MY2 (2023) FINAL MONITORING REPORT

Bull Chute Stream and Riparian Wetland Mitigation Site

**Re: Bull Chute – MY-2 Report (DMS Project No. 100137)
Response to Comments**

Please find below the response to comments on the Bull Chute MY-2 Report provided by DMS, dated January 4, 2024:

Figure 1. Current Conditions Plan View
Tables 4A-I. Stream Visual Stability Assessment
Table 5. Visual Vegetation Assessment
Vegetation Plot Photographs
Site Photo Log

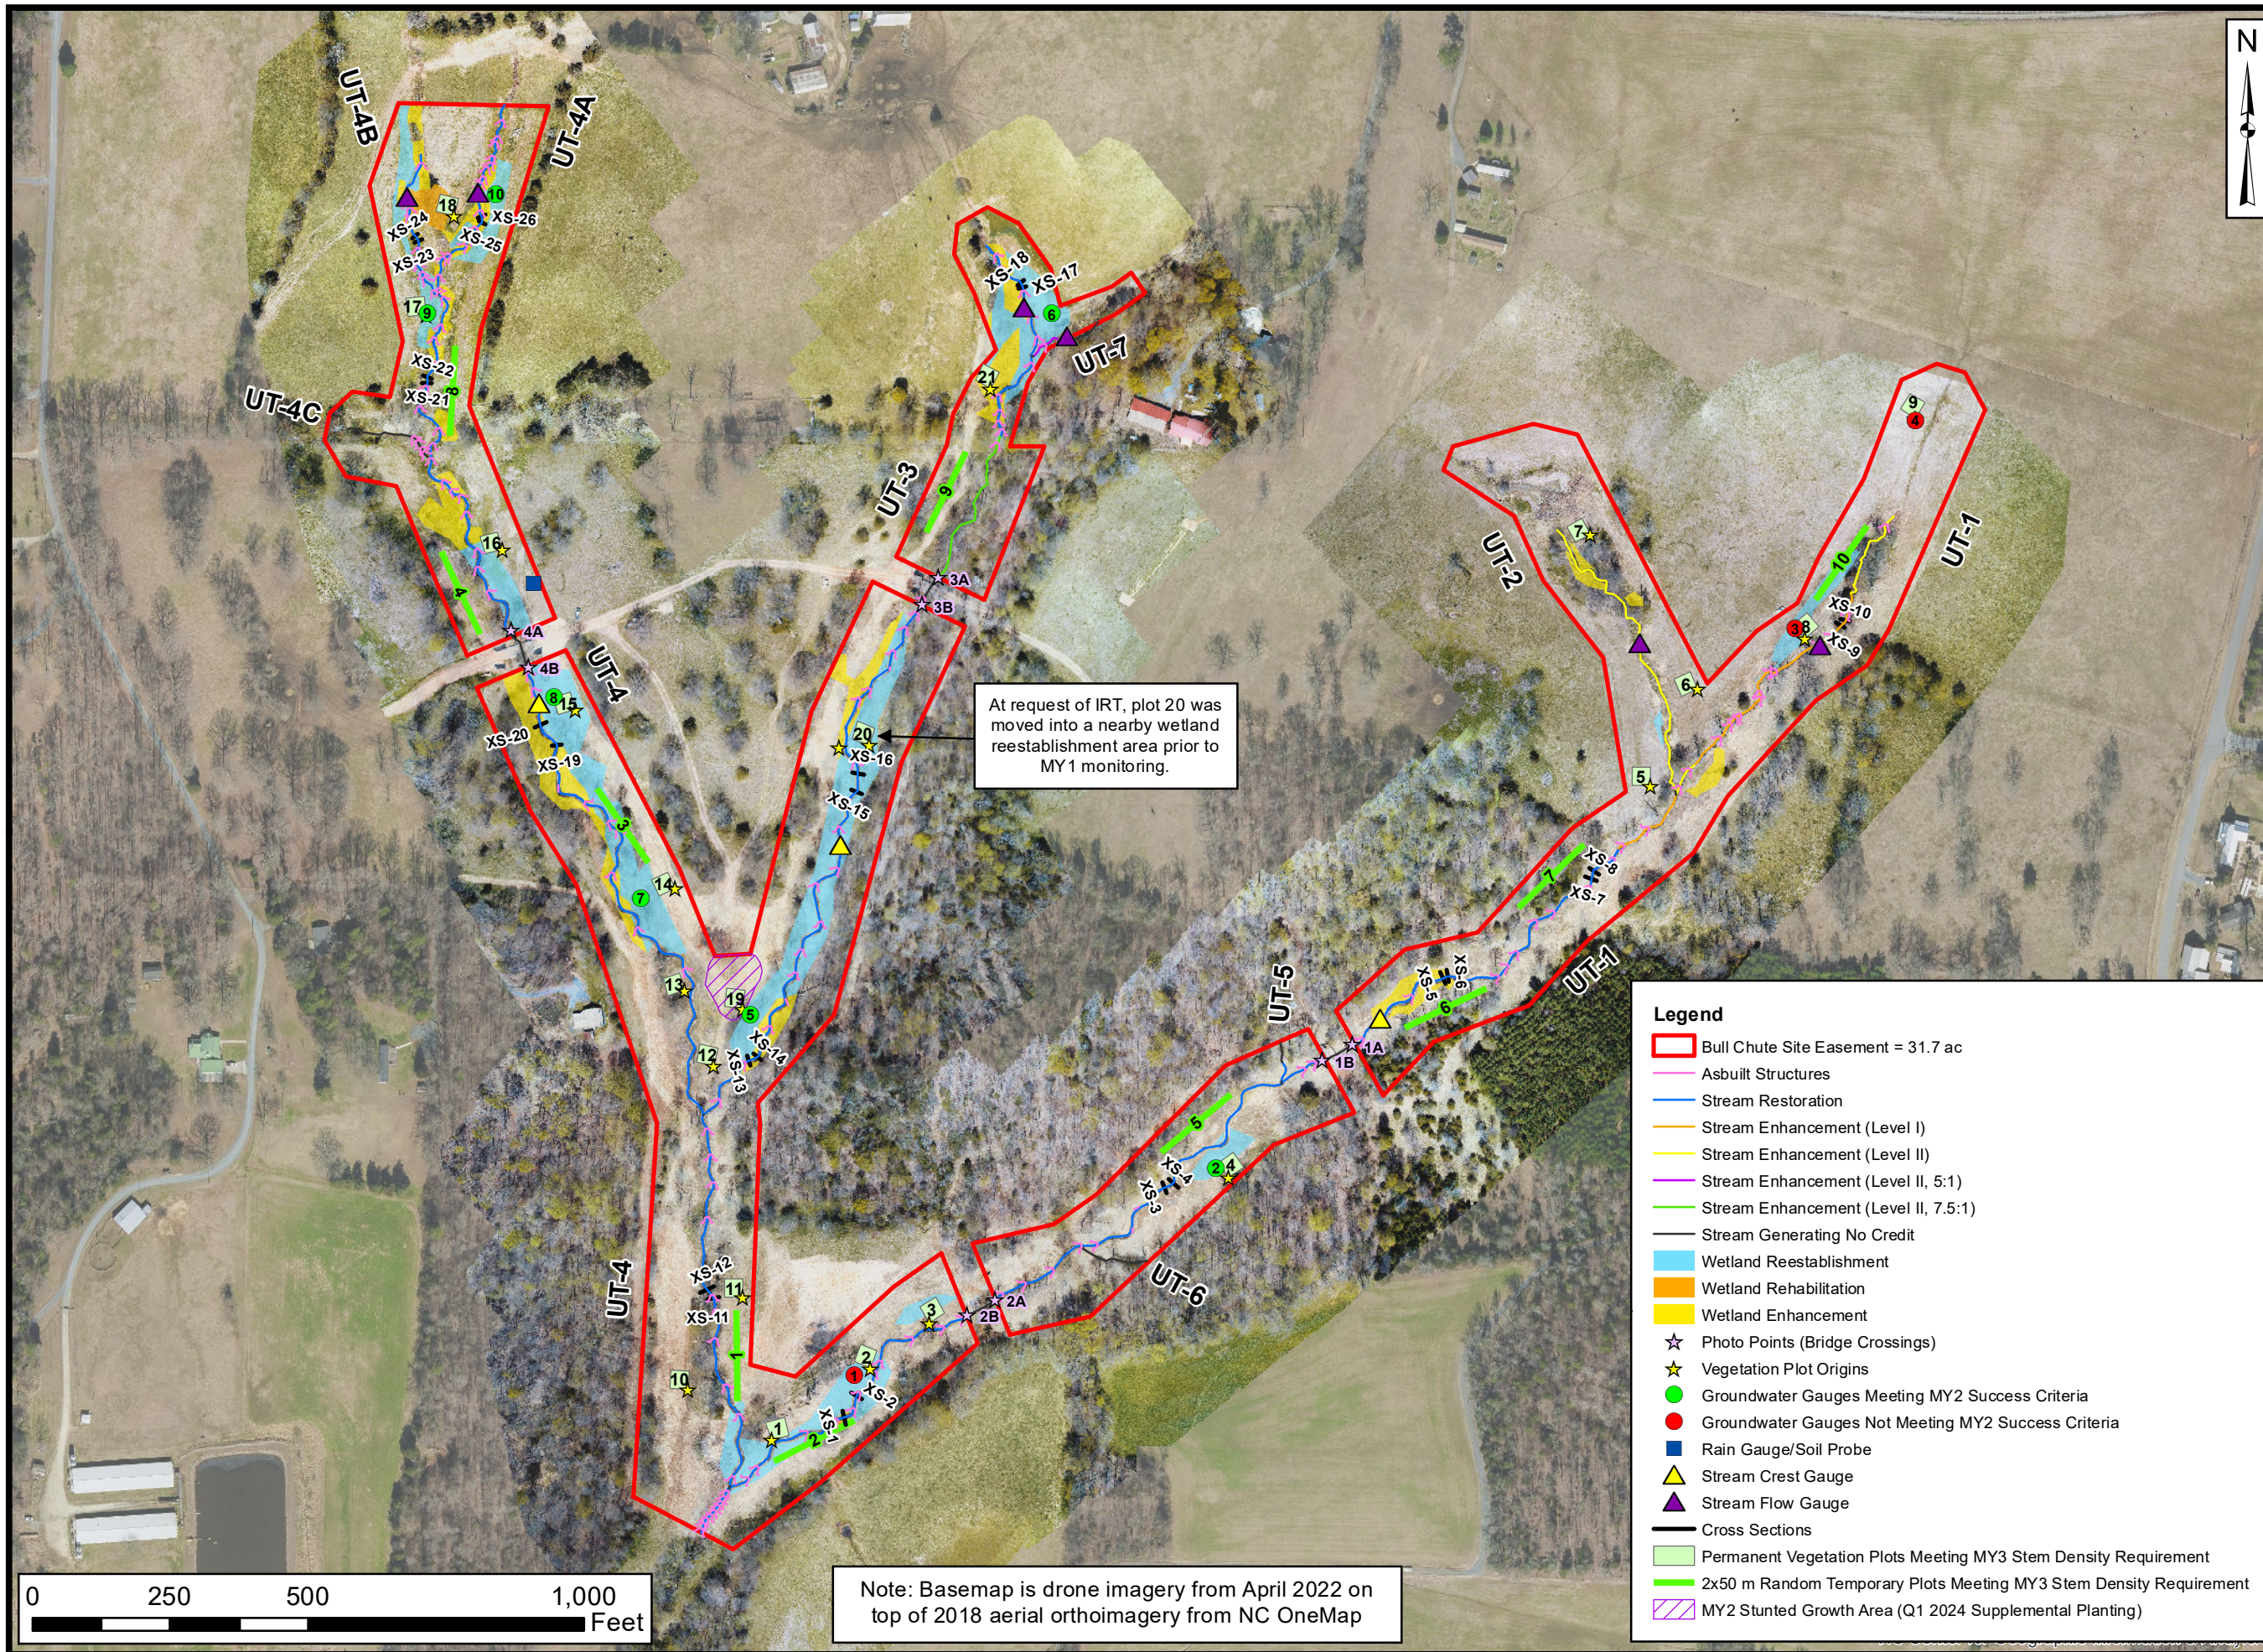
- 11) CCPV – Recommend including the low stem density area near VP19 on the CCPV and updated Table 5 to reflect this area.
Re: The CCPV has been updated to show the low stem density area near VP19 and Table 5 has been updated to reflect this area.

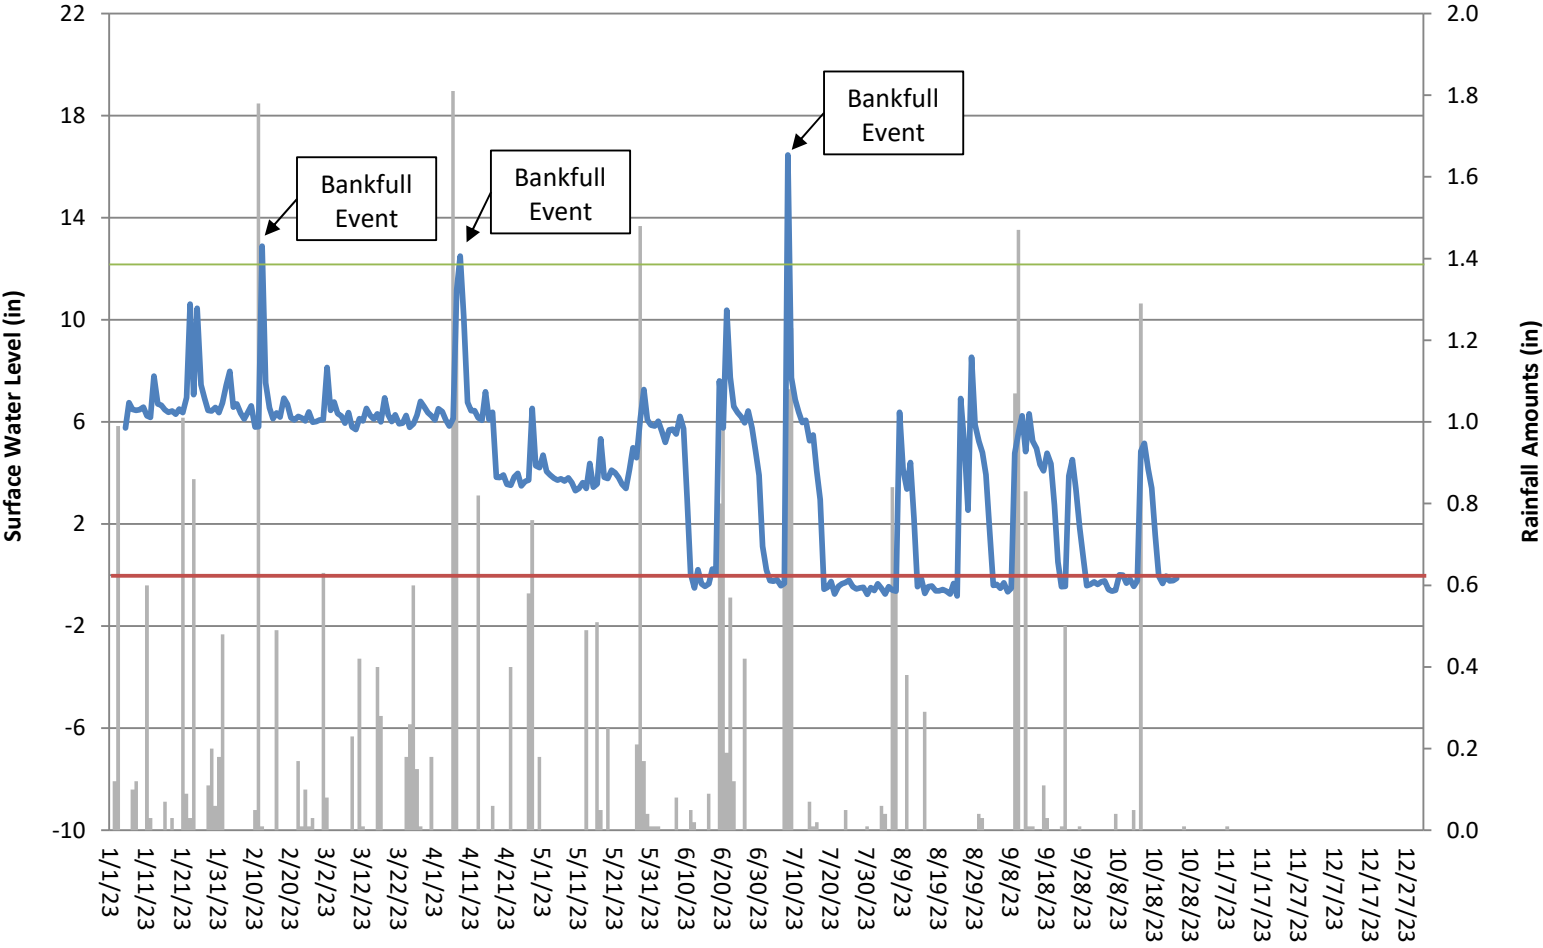
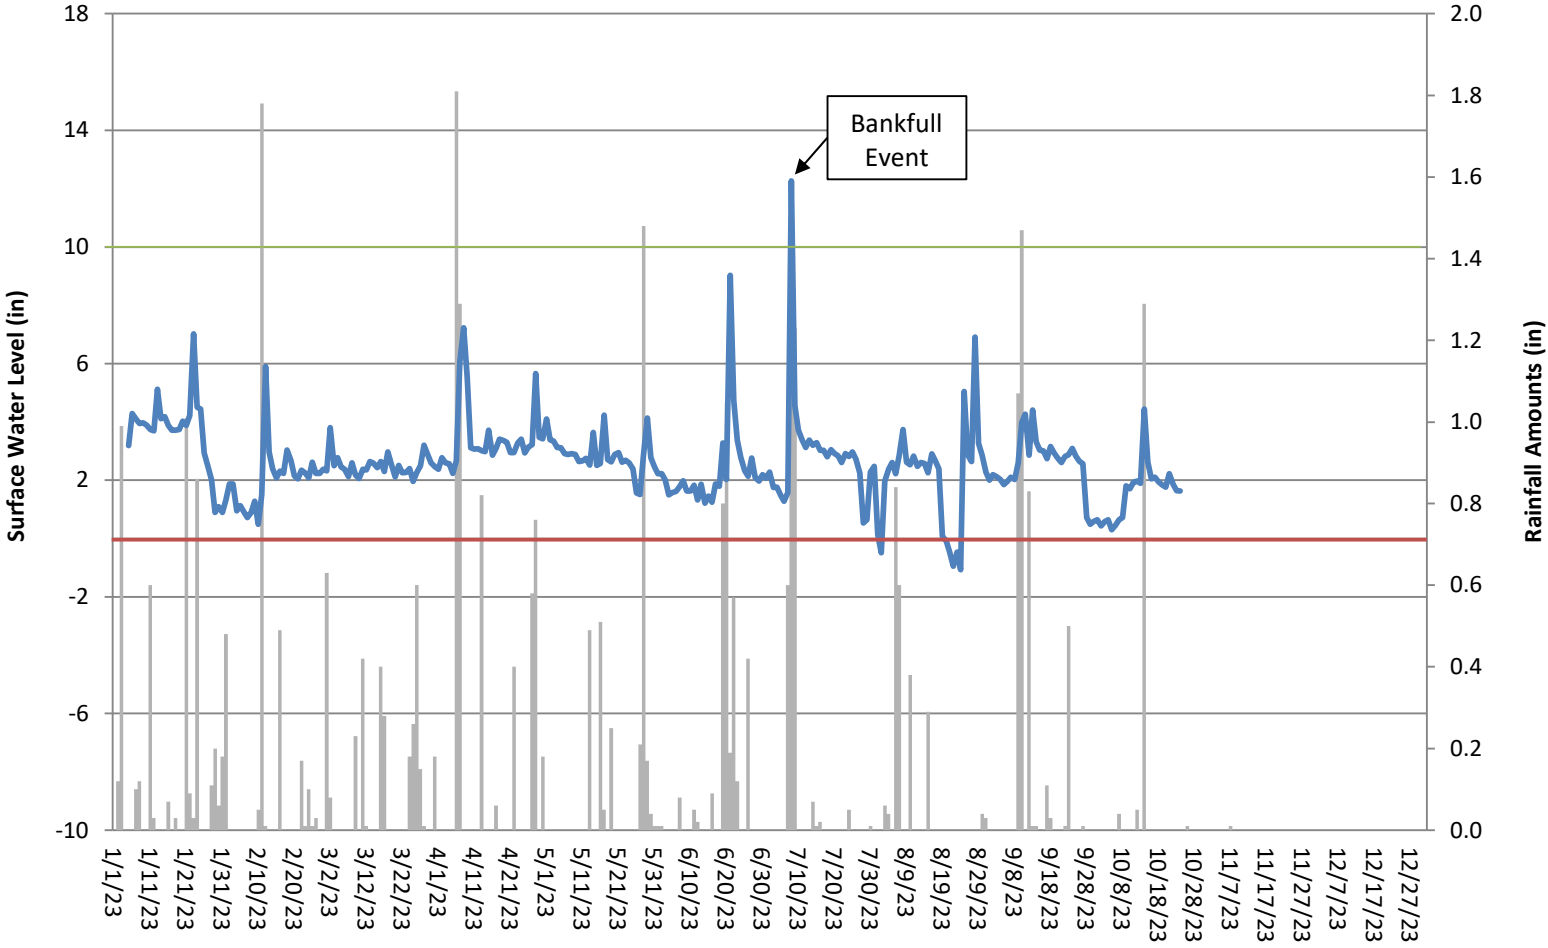
- 14) Bankfull Events: Recommend either only including bankfull photos from the current year or updating the photo label to show MY1, MY2, MY3, etc.
Re: The bankfull event photo labels have been updated to show MY1 and MY2.

Bull Chute Groundwater Gauge 3 Year 2 (2023 Data)

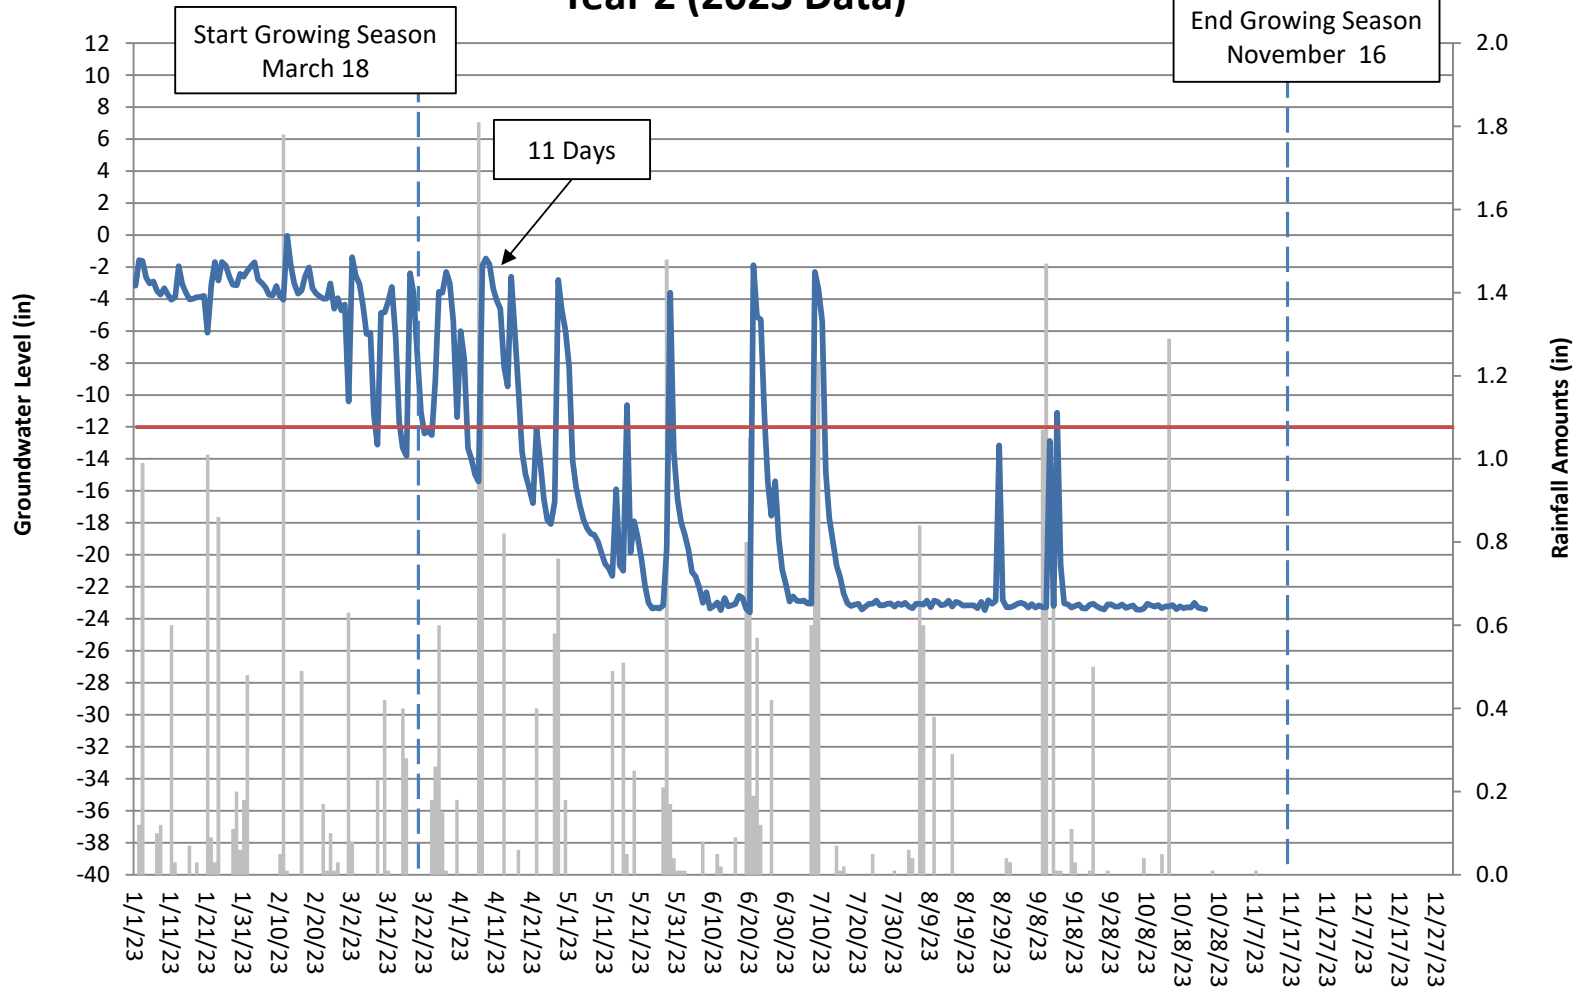
- 5) 3.2 Hydrology Assessment: Recommend revising discussion regarding Gauge 3 in this section. The hydrology data submitted with the draft report shows that Gauge 3 dropped below 12" for 14 days in April. The report indicates there were only 4 days below in April. I recognize that there was a 4 day period in April (4/3-4/6) below 12"

that prevented the success criteria from being met. Revising the discussion for clarity would be helpful.

Re: The discussion of Gauge 3 has been revised to reflect the correct water levels in April.
